Reply on RC2 - response to detailed comments from authors

Author comment on "Machine learning techniques to improve the field performance of low-cost air quality sensors" by Tony Bush et al., Atmos. Meas. Tech. Discuss.,
<https://doi.org/10.5194/amt-2021-282-AC3>, 2022

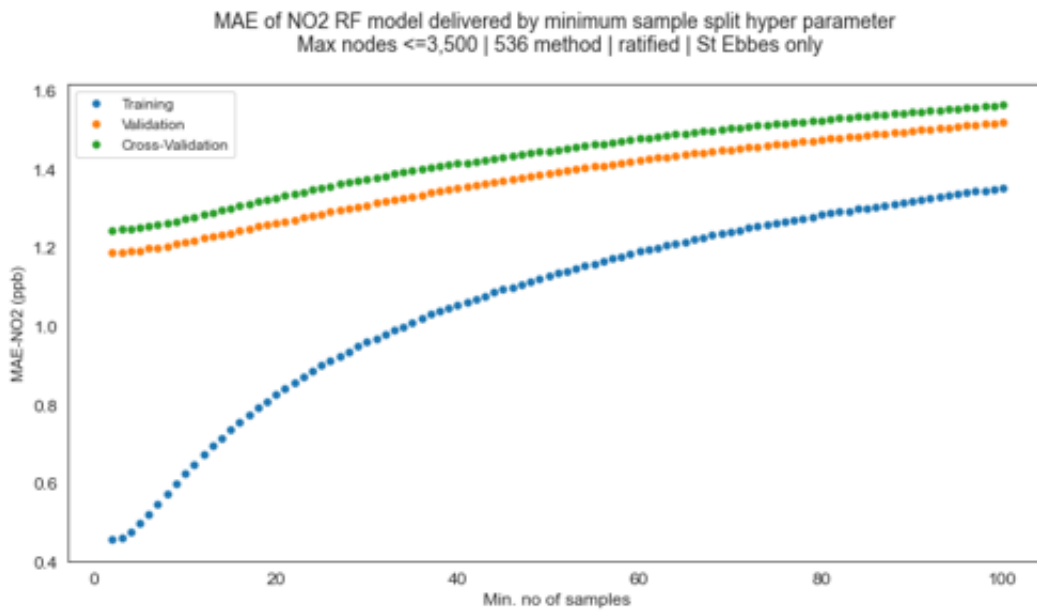
RC2. Random forest regression: My impression is that the hyperparameter settings for training the models allowed very and probably too large trees. In particular the minimum number of samples per node (set to a min of 2 samples per node) appears to be very small and might be prone to overfitting. Please comment this.

AC. The RFR models do not appear overly sensitive to tree size and we have found them to be resistant to overfit. With regard to your min sample split query, our tests showed that this default setting worked well; see the fig below for info. The relatively shallow and uniform gradient of the cross validation & validation curves suggest over-fit at low min sample split values is not a particular issue. I have added comment to the text to indicate that we have performed a reality-check on the hyperparameters chosen to assess the impact of deviations from the parameters identified.
